**SPECIALIST COMMENTS RESPONSE – 88,130,133 UPPER OREWA ROAD AND 53A,53B,55 RUSSELL ROAD, OREWA**

Further to your recent instructions, we have reviewed comments received on 26 June 2025 and have responded to the transport matters raised.

**1 AUCKLAND TRANSPORT – TESSA CRAIG**

**Figure 1: Estimated total daily traffic volume**

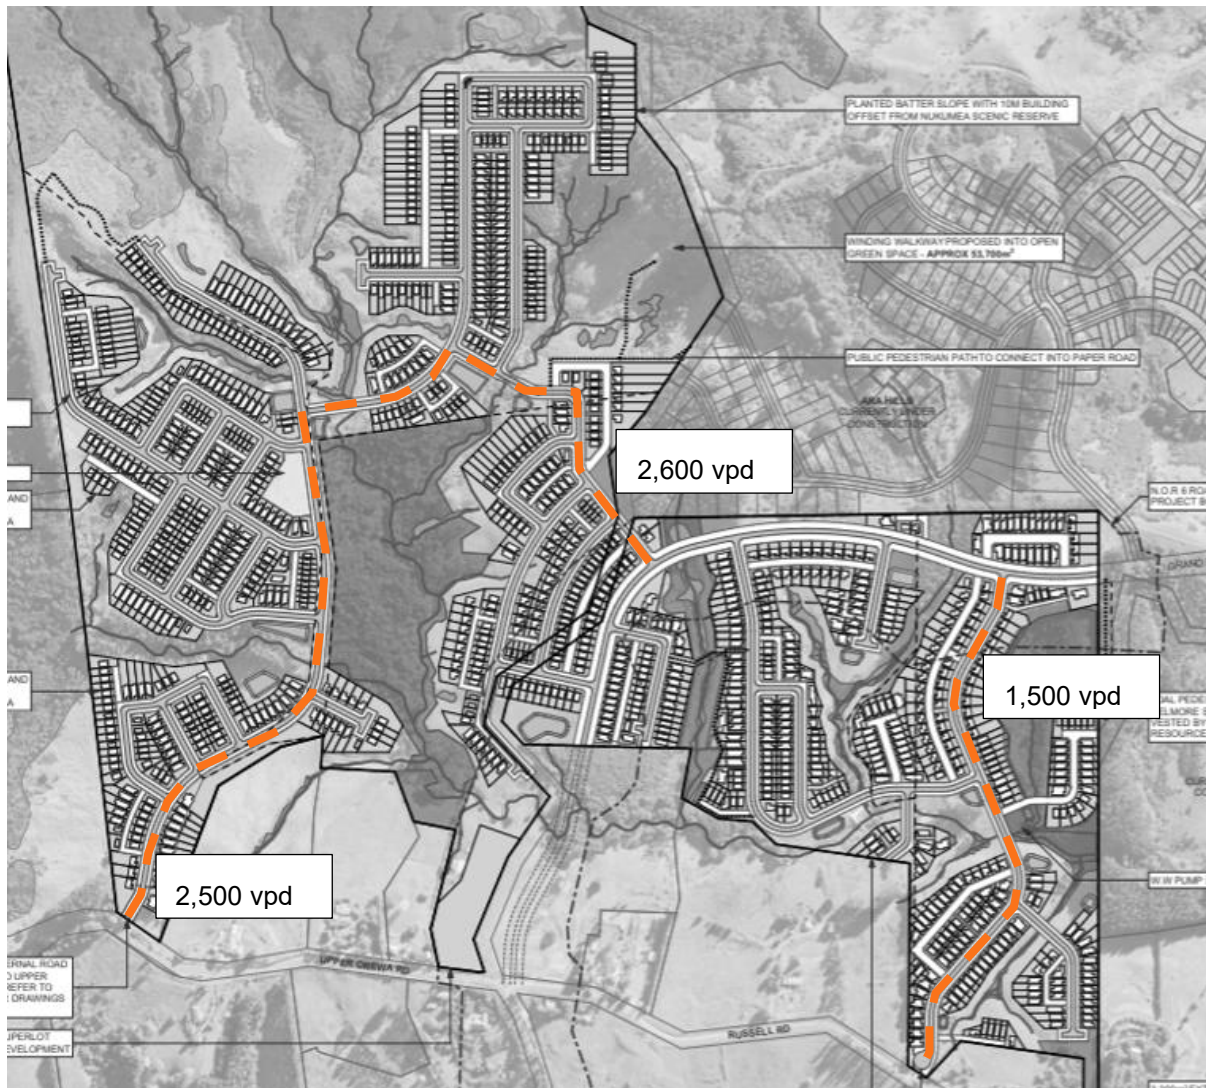
*The standard for these roads should include separated cycling facilities given they will eventually carry over 3000 vehicle per day once the area is fully developed. AT's Engineering Design Code - Cycling Infrastructure requires separate cyclist facilities on new roads with over 3000 vehicles per day using them to the following standard "A Cycleway separated from moving traffic by a narrow raised buffer relies on the physical barrier between different modes to provide real and perceived safety to people on bicycles. It is suitable for streets with local to strategic place significance and low to moderate traffic volumes." These are needed to avoid conflict between vehicles and bikes, minimise conflict between pedestrians and bikes and minimise driveway entrances.*

[Stage 1](#) accommodates approximately 470 dwellings, however not all would use Road 1 (potential collector road) due to other routes available to the NoR6 arterial Road (eg Road 2 and Road 3). It is estimated that 50% of these dwellings would use Road 1, or 240 dwellings. Using the RTA daily trip rate of 0.65 daily trips per dwelling, this equates to 1,500 vehicle per day on Road 1 (maximum at its northern end).

[Stage 2](#) accommodates approximately 780 dwellings. Stage 2 does however have two "links", one to the NoR6 road (Road 5) and one to Upper Ōrewa Road (Road 17). As per the Item 2 above, approximately 30% of the total Delmore site is expected to use Upper Ōrewa Road link (via new roundabout) or approximately 380 dwellings (Road 17). As such the other 400 Stage 2 dwellings will use Road 5 to link to NoR6 Road, essentially resulting in a 50/50 split in Stage 2. As such both these roads will accommodate 2,500-2,600 vpd (0.65 daily trips per dwelling). Figure 1 below summarises the traffic volume.

In this regard, collector roads and separated cycle lanes are generally only considered to be required over 3,000 vpd including within Auckland Transport Roads and Streets Framework (pg 33-50) which has all Collector Road listed as 3,000+ vpd.

Overall, these roads will not cater for 3000 vpd so as per the comment from AT, cycling facilities are not required, nor considered appropriate.

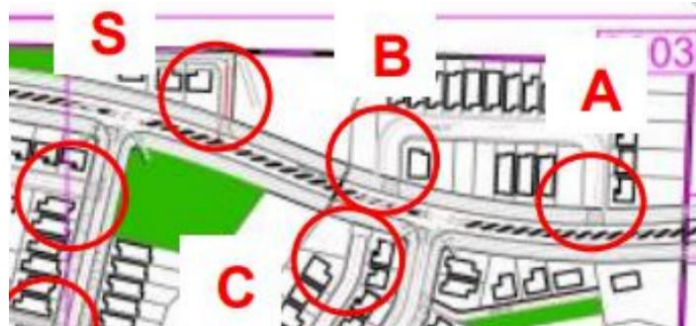
*There is a slightly different alignment between the indicative road shown in the NoR drawings and the proposed road design by the applicant. The applicant alignment is further east in the development roading plans and the stormwater pond is located on the western side of the road.*

*The proposed road alignment is within the designation boundary and should not preclude construction of the connection south to integrate with the proposed roundabout at Upper Ōrewa Road. However, it is notable that the new alignment may require a longer bridge across the stream to the south of the site. This could result in higher future construction costs for AT / Council (given that the applicant is not proposing to construct this section) and other effects than the alignment shown on the NoR plans. The road alignment within the NoR boundary inside the site taken in isolation is acceptable but gives rise to the potential problem outside the site discussed immediately above.*

This is discussed in the NoR 6 Memorandum provided by McKenzie & Co. From a traffic engineering point of view the revised alignment is considered appropriate.

Figure 3: Site road crossing table

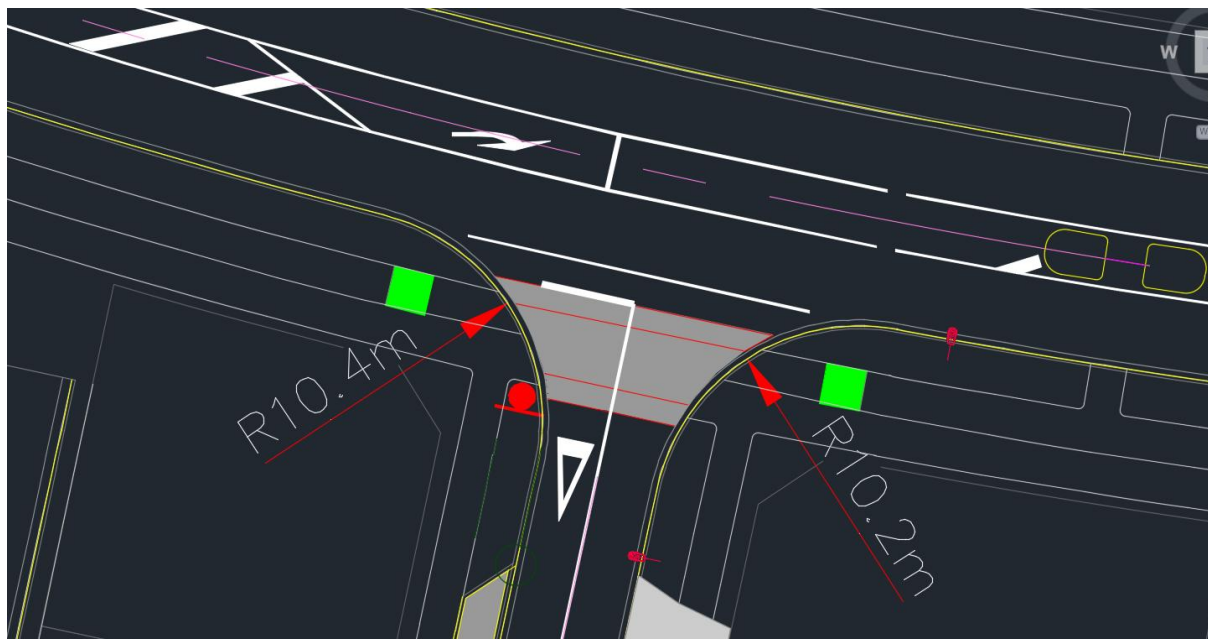
- There is no detail around how cyclists will cross side road intersections and this will need to be agreed with AT. It is recommended that, if the application is granted, a condition is imposed that the applicant works with AT to agree the detailed form of facilities for pedestrians and cyclists in line with AT standards.*
- It is unclear how the separated pedestrian and cycle facilities along the arterial road will integrate with the existing path along Grand Drive. This should be clarified by the applicant and a condition may be necessary to ensure this connection is provided prior to occupation of any houses so that pedestrians and cyclists have suitable access from the outset.*

- i. In terms of the crossing of side roads for cyclists along the NoR, the design as lodged already includes raised tables for this reason (refer to Figure 3 below). The final detailed design of this treatment can be included as a condition of consent.

**Figure 4: Austroads Turning warrant**

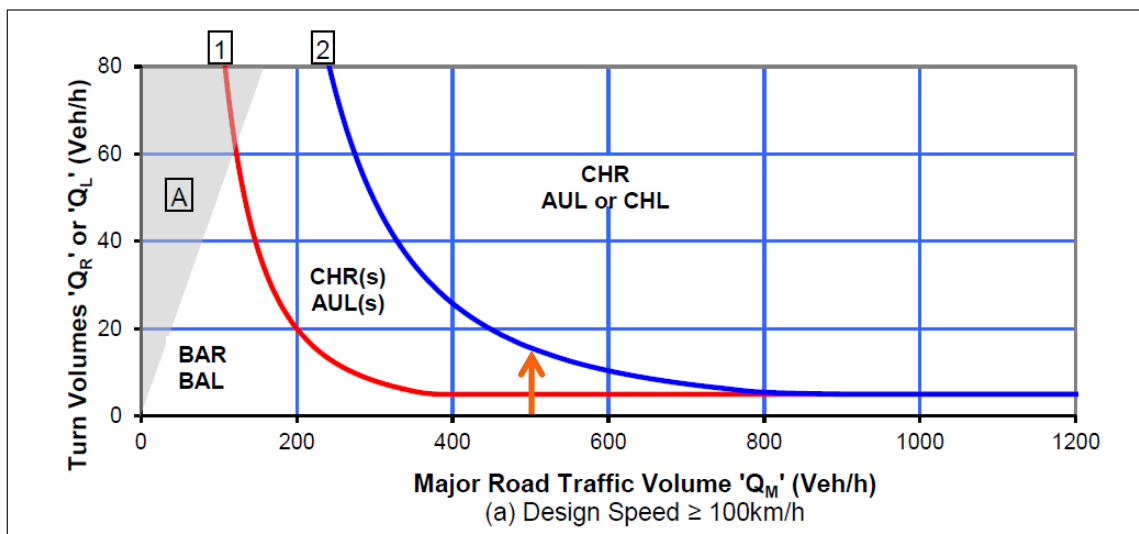
*provides the following statement: "The requirements for a right turn bay at this point is likely to be already triggered by NZTA's internal guidelines (regardless of the Delmore proposal) and thus, is an existing issue which the applicant should not be required to fix, given anticipated scheduling of works and the distance from the roundabout to Delmore". It is not clear if the applicant is stating that the intersection already warrants a right turn bay or will do once the development traffic is added to the intersection. There is no assessment of safety with future turning movements and as such it is possible that the development will exacerbate poor safety outcomes at this intersection leading to increased crashes.*

the Delmore proposal. This is evident below, where from Austroads<sup>1</sup> in a 100km/hr environment with 500 vph (10% of Wainui Roads daily volume) only 5-6 right turning vehicles per hour warrant a “short” auxiliary lane (AUL) and around 15 right turning vehicles per hour warrant a full auxiliary lane (right turn bay). With Upper Orewa Road already having over 130 vph in the commuter peak, the right turn will be well over this level. As such, the requirement for this intersection upgrade is not triggered by the Delmore development, and the applicant should not be required to upgrade it for the reasons identified within the Legal Response Memorandum.

**Figure 5: Stage 1 road gradients**

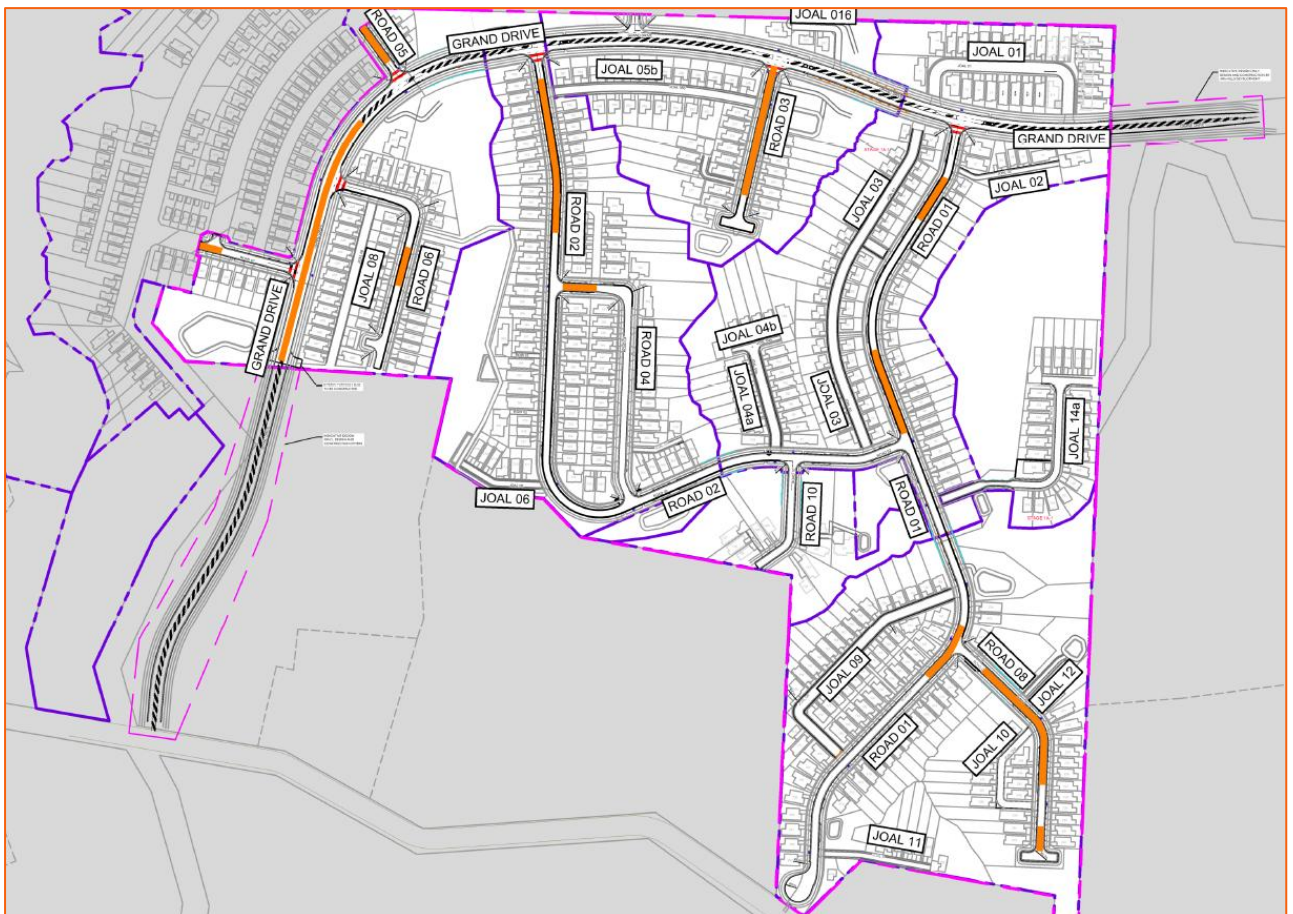
91. The longitudinal gradients of many of the roads are too steep and will discourage active modes. Anything over 8% is considered to potentially discourage walking as a travel mode, including walking to public transport. Figures 2 and 3 of the 12 June letter from Commute show which roads have gradients over 8%. Large proportions of the development require pedestrians walking to public transport routes to use at least some footpaths with a gradient over 8%. I consider that this will contribute to the overall car dependant nature of the proposal and the associated adverse effects described earlier in this memorandum.

Of note Figures 5 and 6 below show the road gradients for both Stage 1 and 2.

- No colour indicates a grade of less than 8%
- Orange indicates a grade of 8-10%
- Red indicates a grade of 10-12.5%

**Figure 10: Upper Ōrewa Road / Road 17 intersection (Roundabout option)**

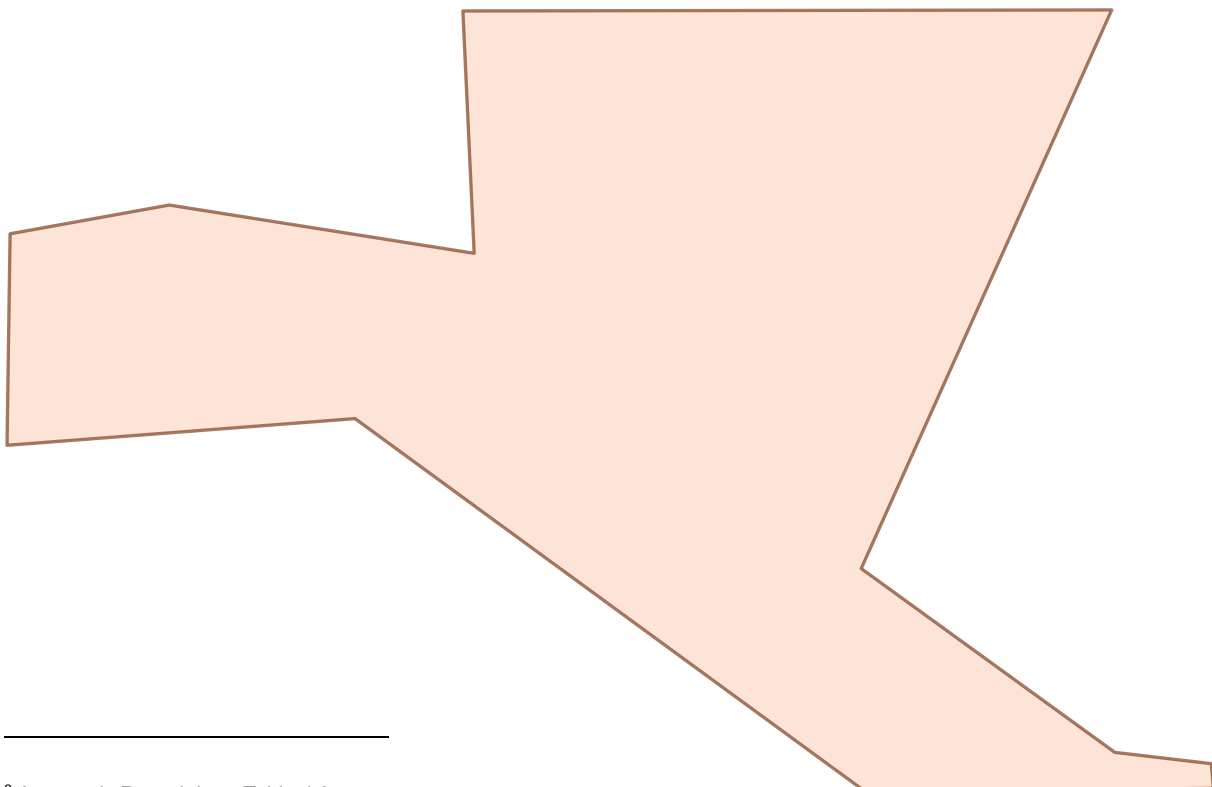
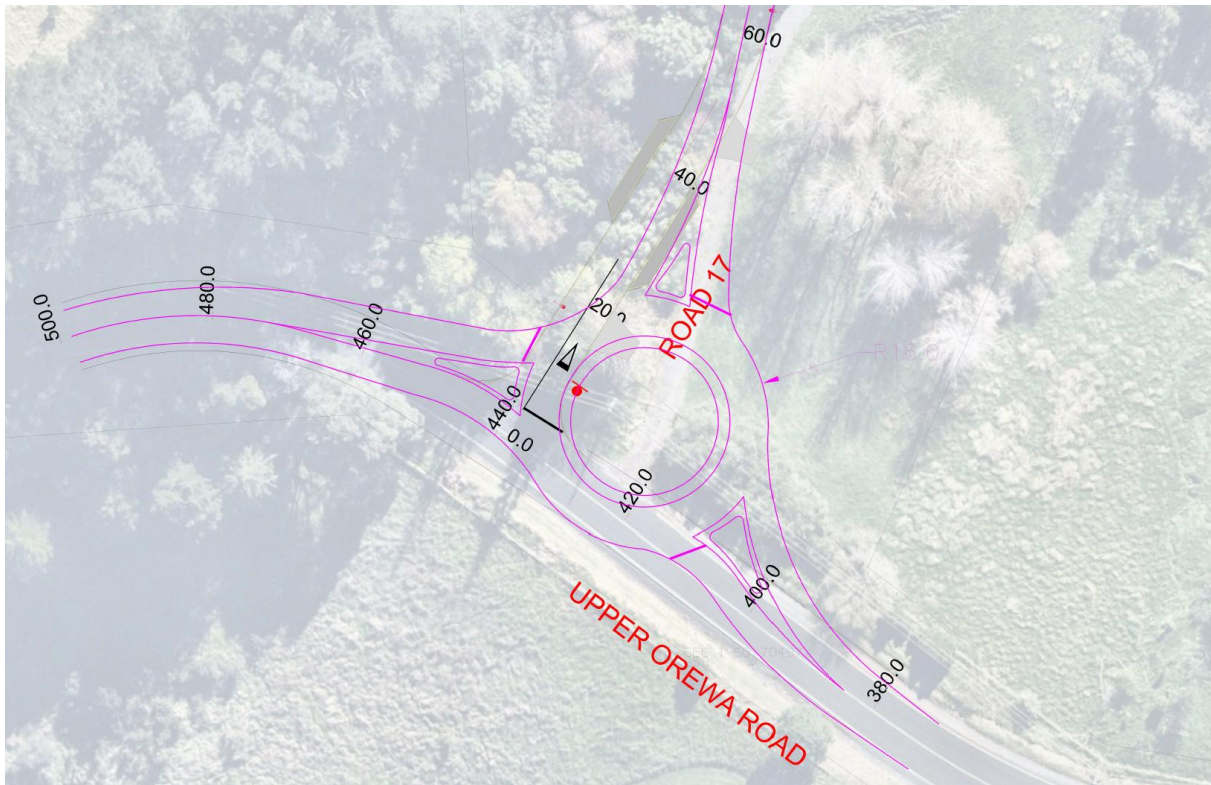
58. In response to concerns raised by Auckland Transport and Council regarding driver sight distances and associated road safety effects the applicant has updated the proposal to include a roundabout at the intersection of Upper Orewa Road and Road 17 (refer Section 1.13 of the 12 June Commute letter).
59. Figure 6 of the letter shows an indicative layout of the roundabout.

Noted the response that this is considered a feasible solution (roundabout). The roundabout option has been developed as per Figure 10 below with a 16m radius (32m outside dimension) roundabout. This shows a roundabout in this location is possible. The road reserve and land owned by the applicant is also shown. No land is required from any neighbouring area. Detailed vehicle tracking can be provided at EPA stage however it is noted the roundabout size of 32m is larger than Austroads<sup>2</sup> minimum for a single lane roundabout (28-29m).
